UNITED STATES PATENT AND TRADEMARK OFFICE

APPLICATION NO.	FILING DATE	FIRST NAMED INVENTOR	ATTORNEY DOCKET NO.	CONFIRMATION NO.
10/765,974	01/29/2004	Yasuhiro Nonaka	P24876	2945
7055	7590	07/25/2005	EXAMINER	
GREENBLUM & BERNSTEIN, P.L.C. 1950 ROLAND CLARKE PLACE RESTON, VA 20191			WALSH, RYAND	
			ART UNIT	PAPER NUMBER
			2852

Office Action Summary

DETAILED ACTION

FIGURE 36 (reference from Okabayashi)

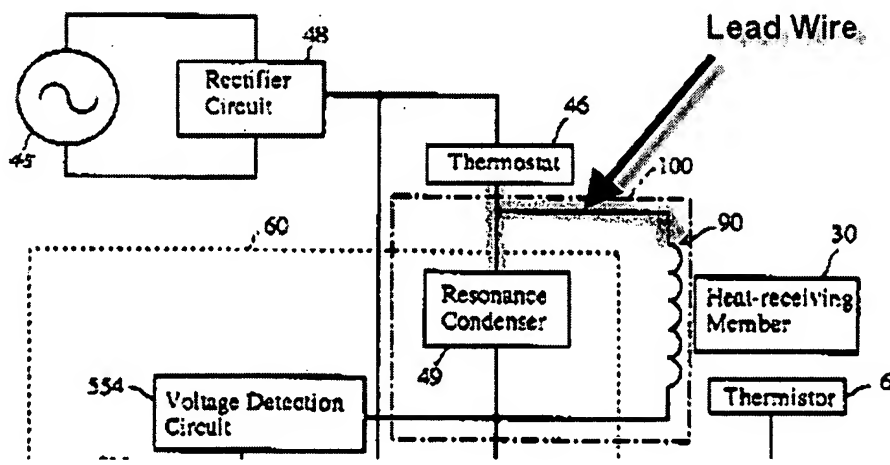
Claims 1-2 and 5-11 are rejected under 35 U.S.C. 102(b) as being anticipated by Okabayashi (US Pat. # 5,794,096).

Regarding claim 1, Okabayashi teaches,

"A heat generating apparatus comprising: a heat generating member (Fig. 36, ref.# 30); an exciting coil (Fig. 36, ref.# 90) provided opposite (Col. 25, Ln. 4-5) to the heat generating member and serving to cause the heat generating member to generate heat by electromagnetic induction; a thermostat (Fig. 36, ref.# 46) provided in the vicinity of the heat generating member and serving to stop supply of a power to the exciting coil when a temperature abnormality of the heat generating member is detected; a power circuit (Fig. 36) having a rectifying circuit (Fig. 36, ref.# 48) and a smoothing circuit (Fig. 36, ref.# 49, note: a resonance circuit [Col. 23, Ln. 7-9] is equivalent to a smoothing circuit) and serving to control the supply of the power to the exciting coil; and a lead wire (see Fig. 36 below) connecting the exciting coil, the thermostat and the power circuit, wherein the thermostat is electrically connected between the rectifying circuit and the smoothing circuit."

Regarding claim 2, Okabayashi teaches,

"wherein the lead wire (Fig. 36, shown above) shares one of two wires connecting the exciting coil (Fig. 36, ref.# 90) to the inverter power circuit (Fig. 36, ref.# 60) and two wires connecting the thermostat (Fig. 36, ref.# 46) to the inverter power circuit (Fig. 36, ref.# 60)."

"A heat generating apparatus comprising: a heat generating member (Fig. 36, ref.# 30); an exciting coil (Fig. 36, ref.# 90) provided opposite (Col. 25, Ln. 4-5) to the heat generating member and serving to cause the heat generating member to generate heat by electromagnetic induction; a first power source (Fig. 36, ref.# 45) for supplying a power to the exciting coil; a switching unit (Fig. 36, ref.# 44 and Col. 8, Ln. 51-57) for switching ON/OFF of the supply of the power from the first power source to the exciting coil (Col. 22, Ln. 12-14); a second power source (Fig. 36, ref.# 53) for driving the switching unit (Col. 21, Ln. 17-18); and a thermostat (Fig. 36, ref.# 46) for stopping the supply of the power from the first power source to the exciting coil when the heat generating member exceeds a predetermined temperature."

"The heat generating apparatus as claimed in claim 5, further comprising, a switching unit voltage detecting circuit (Fig. 36, ref.# 554) which detects that a voltage to be applied to the switching unit exceeds a safe operating voltage range; and a control circuit (Fig. 36, ref.# 525) which controls a power to be supplied to the coil in response to a detection signal of the switching unit voltage detecting circuit."

“wherein when the switching unit voltage detecting circuit (Fig. 36, ref.# 554) detects that the safe operating voltage range of the switching unit is exceeded, the control circuit (Fig. 36, ref.# 525) limits the supply of the power to the exciting coil to carry out a control in such a manner that the voltage to be applied to the switching unit maintains a safe operating voltage range limitation (Col. 26,Ln. 31-41).”

“wherein when the switching unit voltage detecting circuit (Fig. 36, ref.# 554) detects that the safe operating voltage range of the switching unit is exceeded, the control circuit (Fig. 36, ref.# 525) detects the supply of the power to the exciting coil and makes the voltage to be applied to the switching unit attenuate on an optional level within a safe operating voltage range limitation(Col. 26,Ln. 31-41).”

“wherein when the switching unit voltage detecting circuit (Fig. 36, ref.# 554) detects that the safe operating voltage range of the switching unit is exceeded, the control circuit (Fig. 36, ref.# 525) stops the supply of the power to the exciting coil (Col. 26,Ln. 31-41).”

“An electromagnetic induction heating fixing apparatus (see title) for an image forming apparatus, comprising: a heat generating member (Fig. 36, ref.# 30); an exciting coil (Fig. 36, ref.# 90) provided opposite (Col. 25, Ln. 4-5) to the heat generating member and serving to cause the heat generating member to generate heat by electromagnetic induction; a thermostat (Fig. 36, ref.# 46) provided in the vicinity of

the heat generating member and serving to stop supply of a power to the exciting coil when a temperature abnormality of the heat generating member is detected; a power circuit (Fig. 36) having a rectifying circuit (Fig. 36, ref.# 48) and a smoothing circuit (Fig. 36, ref.# 49, note: a resonance circuit [Col. 23, Ln. 7-9] is equivalent to a smoothing circuit) and serving to control the supply of the power to the exciting coil; and a lead wire (see Fig. 36 above) connecting the exciting coil, the thermostat and the power circuit, wherein the thermostat is electrically connected between the rectifying circuit and the smoothing circuit."

Regarding claims 3 and 4 Okabayashi discloses "A heat generating apparatus comprising: a heat generating member (Fig. 36, ref.# 30); an exciting coil (Fig. 36, ref.# 90) provided opposite (Col. 25, Ln. 4-5) to the heat generating member and serving to cause the heat generating member to generate heat by electromagnetic induction; a thermostat (Fig. 36, ref.# 46) provided in the vicinity of the heat generating member and serving to stop supply of a power to the exciting coil when a temperature abnormality of the heat generating member is detected; a power circuit (Fig. 36) having a rectifying

circuit (Fig. 36, ref.# 48) and a smoothing circuit (Fig. 36, ref.# 49, note: a resonance circuit [Col. 23, Ln. 7-9] is equivalent to a smoothing circuit) and serving to control the supply of the power to the exciting coil; and a lead wire (see Fig. 36 below) connecting the exciting coil, the thermostat and the power circuit, wherein the thermostat is electrically connected between the rectifying circuit and the smoothing circuit." In claim 3, Okabayashi does not teach "wherein the lead wire includes a connector containing at least four pins having two lead connecting the exciting coil to the inverter power circuit and one wire connecting the thermostat to the inverter power circuit, and changes a connecting position of the connector having one wire connecting the thermostat to the inverter power circuit depending on a supply voltage and prevents an erroneous connection of the exciting coil to the inverter circuit based on the supply voltage." Also, in claim 4 Okabayashi does not teach, "wherein the lead wire includes a connector containing two pins having two wires connecting the exciting coil to the inverter power circuit and a connector containing at least two pins having one wire connecting the thermostat to the inverter power circuit, and changes a connecting position of the connector having one wire connecting the thermostat to the inverter power circuit depending on a supply voltage and prevents an erroneous connection of the exciting coil to the inverter circuit based on the supply voltage."
